Interactive comment on “Beaver dam influences on streamflow hydraulic properties and thermal regimes” by Milada Majerova et al.

Thank you for the Reviewer 1 comments! We responded to individual comments below. The numbering was kept from original RC1.

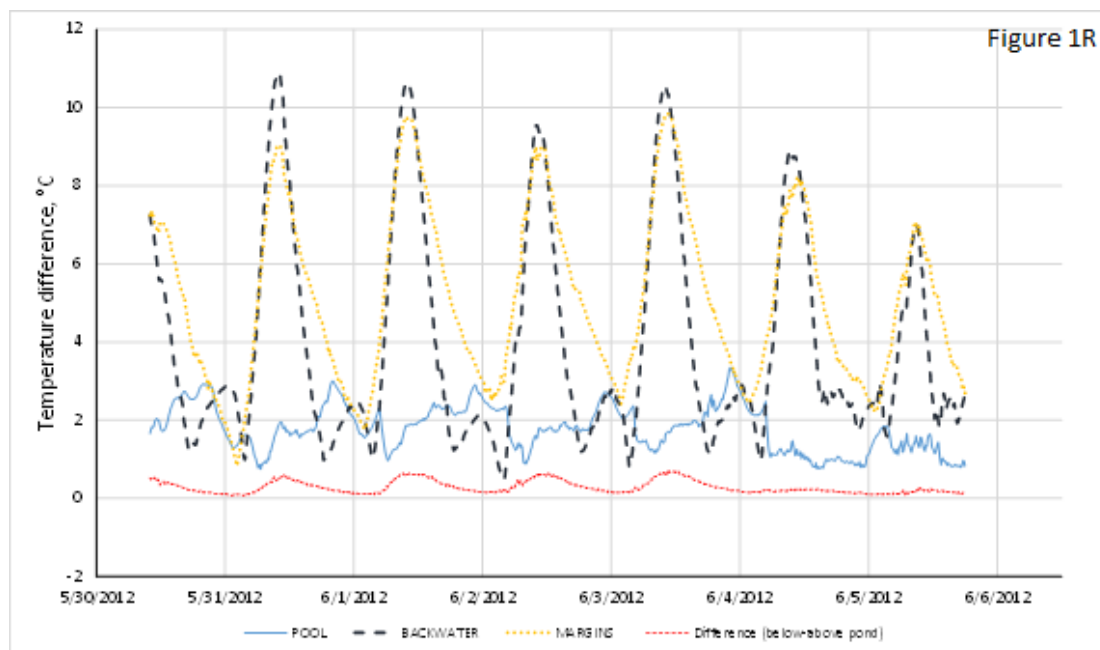
8. The study focused on a three-week period in September, which was characterized by low-flow conditions. Based on the literature and process considerations, I would

expect thermal heterogeneity to increase with decreasing streamflow and with increasing solar radiation. It is unclear whether the observed patterns in this study would be relevant for other periods, particularly earlier in the summer when both streamflow and solar radiation would be higher. This concern could be addressed to some degree by focusing on the variability of heterogeneity within the study period. (e.g., contrasting day and night, and days with differing insolation).

- We agree that with a decrease in flow, the thermal heterogeneity among individual geomorphic units within beaver dams would increase. This highlights the importance of these units being present during low summer flows. However, temperature observations (Figure R1) from higher flows ($Q = 0.283$ cms where the original study was 0.19 cms), still show that thermal variability within each unit (maximum minus minimum temperature for the unit at given time) even though the difference between individual units is not as apparent as the lower flows. Regardless, the trends observed during September low flows were preserved with backwater showing the highest variability and margins and pools following. Even under higher flows, the difference in temperatures above and below the pond (reaching a maximum of 0.5 °C, red line, Figure R1) provides a nice contrast to the thermal variability present within the geomorphic units. In short, the warming effect of the pond and the role of the different geomorphic units are still observable under higher flows. A similar discussion and a plot showing temperature data from this additional time period will be incorporated into the new MS.

Figure R2 Air temperature, solar radiation, and discharge for study period.

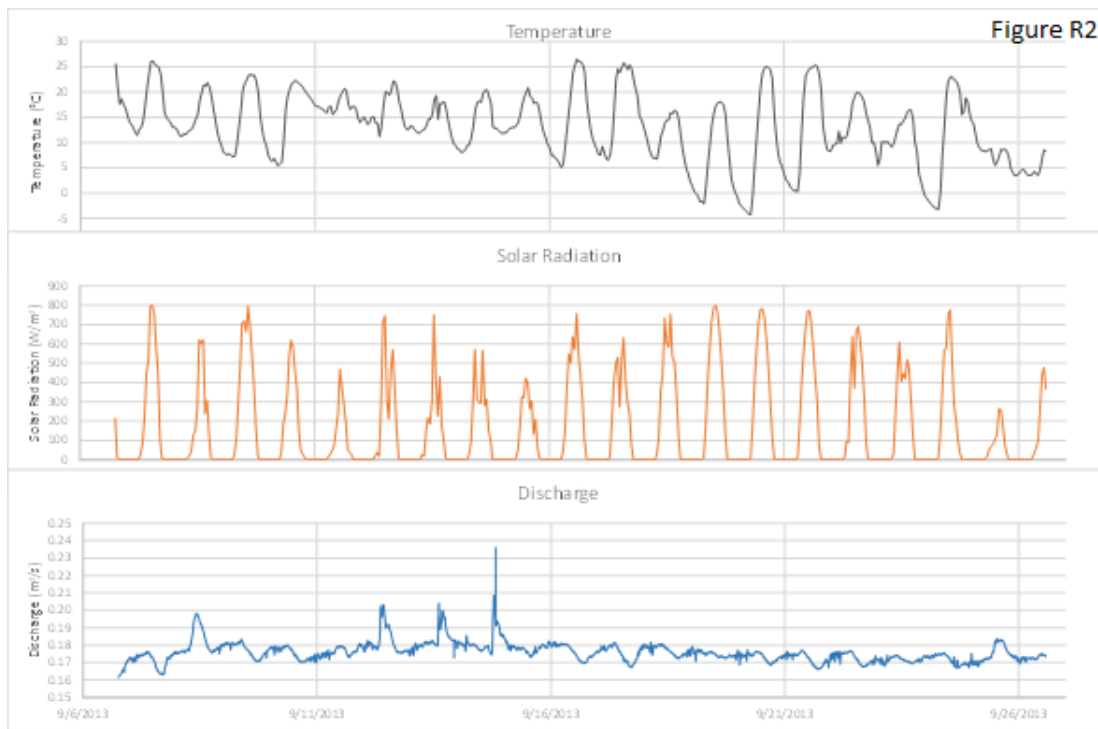
9. Following on the preceding point, do the authors have meteorological and stream-flow data for the study period? This information would be useful for interpreting the time series plots and the within-period variation of thermal heterogeneity (Figures 5 and 6).

- Thank you for the comment. We will add following figure (Figure R2) showing air temperature, solar radiation, and stream flow to the Supplemental Information.

Figure R3 Distribution of temperatures recorded in the warmest of each of the four habitat units on the warmest day during the study period. The added solid red line represents the suitability of stream temperature for cutthroat trout growth where the

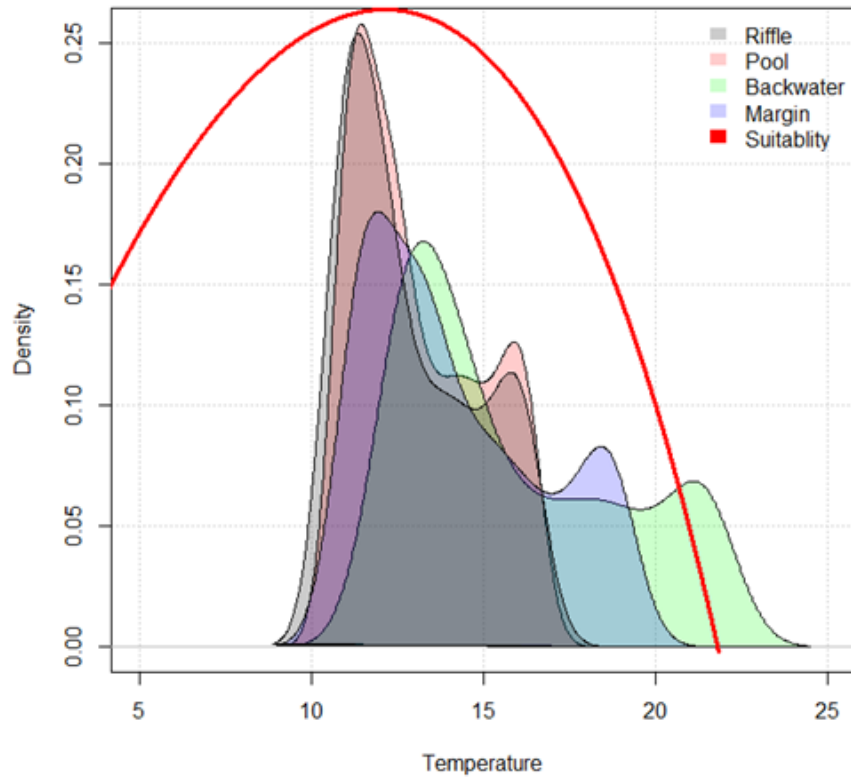
10. The authors relate the observed temperature variability to fish habitat suitability, but

only in a passing way (line 359ff). Perhaps this discussion topic could be developed in more detail with reference to the relative roles of temperature and depth/velocity as controls on habitat suitability. For example, environmental flow needs are often determined with respect to depth and velocity, with no reference to thermal regime (Olden and Naiman, 2010). In the current case, do the locations with optimal temperatures coincide with optimal hydraulic conditions for the resident fish species?

- We agree with the reviewers that assessing the fish habitat suitability in relationship to temperature would benefit this manuscript. Many papers that explore the effects of beaver ponds on stream temperature and fish have focused on their positive or detrimental effects on maximum stream temperature (Collen and Gibson 2001). Our findings within this paper indicate that the presence of beaver ponds increases the density of a subset of geomorphic units which then increases the thermal, depth, and velocity variability. In our revised manuscript we will seek to better portray how the observed 15oC daily temperature variability (or range in observed temperature differences) within a beaver dam occurs across the geomorphic units assessed. In making this argument, we will demonstrate that this increased variability provides optimal thermal habitat for cutthroat trout (the native fish species of interest) at all times even if temperatures in some areas are sub-optimal (Figure R3). Furthermore, we will expand this discussion to argue that although temperature in some of the habitat units may not have been thermally suitable during the time this beaver dam complex was instrumented, the units showing warm day temperatures during summer/early fall may be critical to providing additional time for growth during the spring and fall (Olden and Naiman 2010). We will make a similar argument when it comes to areas with lower flow velocities. These beaver ponds provide ideal conditions during winter as the low flow velocity minimizes metabolic cost. In the spring when cutthroat spawn, they can find refuge in the low velocities areas, but have nearby access to flow velocities that are suitable for building redds and laying eggs. We will additionally discuss how these temperature distributions differ as you remove the geomorphic unit density created within the beaver dam complex.

Figure R4 Figure 6b from the original MS (top) and the data from Figure 6b with the upstream data shifted 40 minutes to account for travel time (bottom).

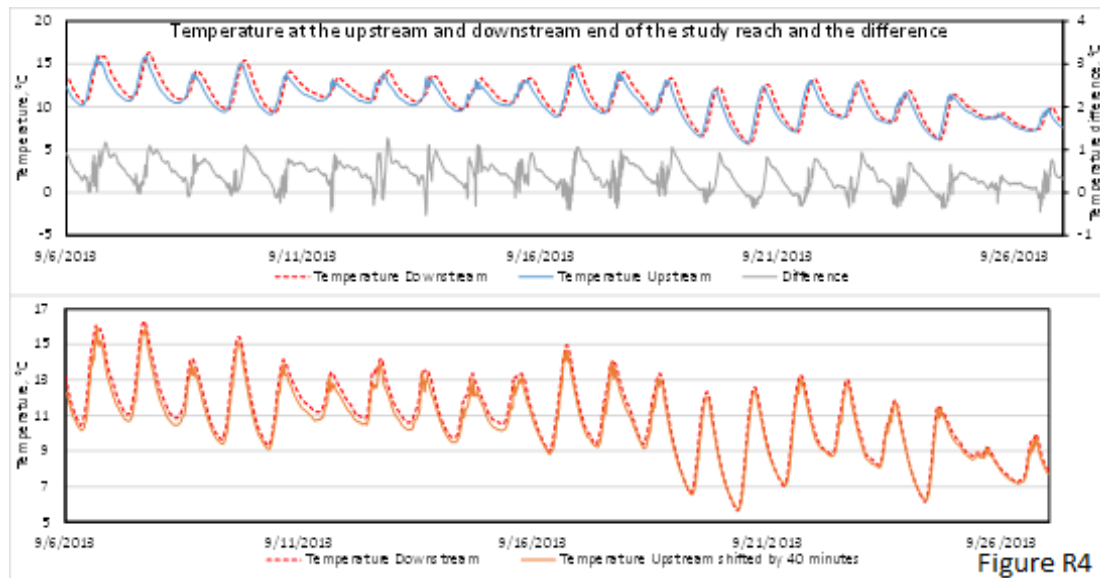
11. In Figures 5 and 6, temperature differences are shown between upstream and downstream locations. Examination of the figures suggests that much of the difference is caused by an advective shift in the timing of the diel temperature wave rather than changes in temperature caused by energy exchange (especially Figure 6B). It may be interesting to account for this effect by shifting the time series to account for travel time, and then looking at temperature differences, as was done by Rutherford et al. (2004).

- We are assuming that the reviewer was referring to Figure 5B. This comment presents an interesting idea, however, the travel time is only 43 minutes based on the mean velocity of 0.25 m/s. As shown in the plots below (Figure R4), the lag in temperatures upstream and downstream is due in part to advective influences (or primarily advective influences during some days). When applying the shift (see bottom subplot), the rising limb of the temperatures are aligned, but for many days, a small lag remains in the falling limb. As you mention, this suggests that the difference in temperatures are due to the actual heat exchanges that occur over the study reach. This can also be seen due in the slightly higher max temperatures and higher average temperatures at the downstream end. With this shift applied, the rate of warming is the same at both locations and they reach the maximum temperature at approximately the same time. However, the downstream temperature sensors is 0.38 °C warmer on average with the largest consistent differences occurring during the peak and times of cooling. Based on some calculations from the modeling results in Stout et al. (2017), we found that the total water volume/surface area in the reach feeding the upstream sensor was half that of the beaver dam impacted reach shown here that influences the downstream sensor. This may suggest that solar radiation (that can penetrate the water column) will warm different depth waters at a similar rate, however, the surface heat fluxes responsible for cooling (sensible, radiative, and latent heat fluxes) will cool deeper portions of the system more slowly.
